# UNITED STATES PATENT AND TRADEMARK OFFICE

APPLICATION NO.	FILING DATE	FIRST NAMED INVENTOR	ATTORNEY DOCKET NO.	CONFIRMATION NO.
10/575,526	12/08/2006	Richard Spitz	10191/4608	9368
26646 7590 08/26/2010 KENYON & KENYON LLP ONE BROADWAY NEW YORK, NY 10004				
EXAMINER				
HSIEH, HSIN YI				
ART UNIT		PAPER NUMBER		
2811				
MAIL DATE		DELIVERY MODE		
08/26/2010		PAPER

### Office Action Summary

## **DETAILED ACTION**

A portion of Fig. 1 of Spitz et al. showing the trench and the first bevel

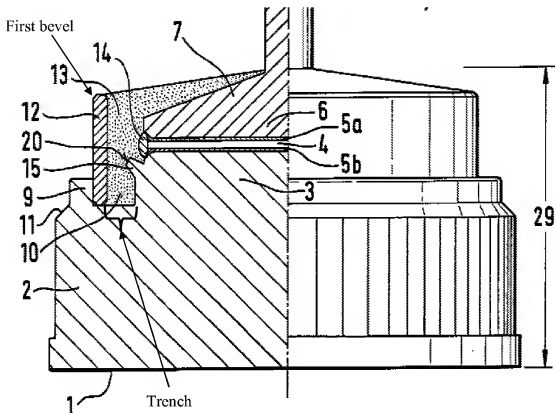
6. **Claims 15, 16 and 26** are rejected under 35 U.S.C. 102(b) as being anticipated by Spitz et al. (US 6,060,776 A).
7. Regarding **claim 15**, Spitz et al. teach a press-fit diode (rectifier diode 100; Fig. 1, col. 3 lines 15-16), comprising: a head wire (8; Fig. 1, col. 3 lines 21-22); a base (2; Fig. 1, col. 3 line 17); a chip (semiconductor chip 4; Fig. 1, col. 3 lines 19-20) connected via solder layers (solder 5a and 5b; Fig. 1, col. 3 lines 19-21) to the head wire (8) and to the base (2; Fig. 1, col. 3 lines 18-21); at least a first bevel (the bevel at the top outer corner of 12; see Fig. 1 below) located at a top (12 is a top portion of 12, 13, and 2; see Fig. 1 below) of a housing (12, 13 and 2) and a second bevel (press-fit region 11; Fig. 1, col. 3 line 25) located at a bottom (2 is a bottom portion

of 12, 13, and 2) of the housing (12, 13 and 2), wherein the first and second bevels (the bevel at the top outer corner of 12 and 11) enable press-fitting of the diode (100; the bevel at the top outer corner of 12 eases the insertion of the diode and 11 is pressed fitted to the rectifier arrangement 36; see Figs. 2 and 3, col. 4 lines 32-54); and a plastic sheathing (protective sheath 12 and a package 13 of casting resin composition; Fig. 1, col. 3 lines 30-32 and 66-67) which includes a sleeve (protective sheath 12; Fig. 1, col. 3 lines 30-32) and is situated at least in an area around the chip (4; the sleeve 12 surrounds the chip 4; see Fig. 1) and forms a mechanical connection between the base (2) and the head wire (8; see Fig. 1, the sleeve 12 is mechanically connected to 2 and 8), wherein the base (2) at least partially encloses the plastic sheathing (12 and 13) and forms the housing (12, 13 and 2) with the plastic sheathing (12 and 13), and wherein the base (2) includes at least one undercut (shoulder 15; Fig. 1, col. 3 lines 36-37) which extends into the plastic sheathing (12 and 13; see Fig. 1), and wherein a trench (the trench between 12 and 2 filled with 13; see Fig. 1 below) is provided between the sleeve (12) of the plastic sheathing (12 and 13) and the base (2; see Fig. 1 below).

A portion of Fig. 1 of Spitz et al. showing the trench and the outer area of base

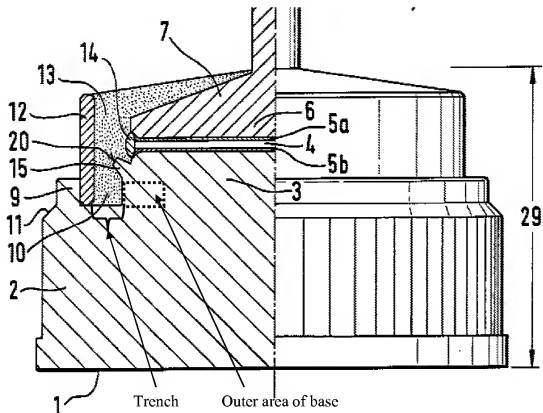
16. Regarding **claim 20**, Spitz et al. also teach the press-fit diode as recited in claim 17, wherein the trench (the trench between 12 and 2 filled with 13) has a predetermined depth (see Fig. 1 below) and is provided between the sleeve (12) and an outer area of the base (a portion of base 2 in contact with the right hand side of the trench 10; see the figure below).

A portion of Fig. 1 of Spitz et al. showing the first area and the second area

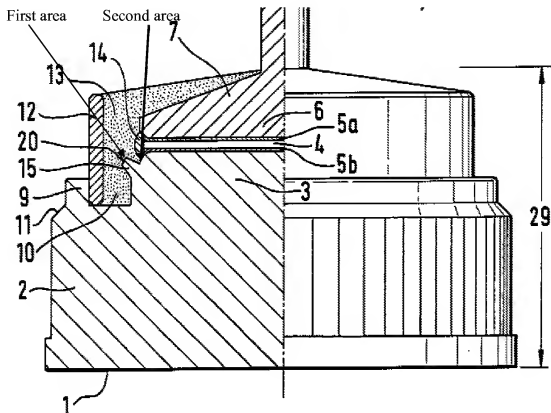
20. Regarding **claim 24**, Spitz et al. also teach the press-fit diode as recited in claim 17, wherein the base (2) includes an outer region (shoulder 15; Fig. 1, col. 3 line 37) having a first area (top area) with a first inner diameter (the diameter corresponds to the inner side of the shoulder 15 at the top) and a second area (lower area) with a second inner diameter (the diameter corresponds to the inner side of the shoulder 15 at a lower position) smaller than the first inner diameter (see the figure below).
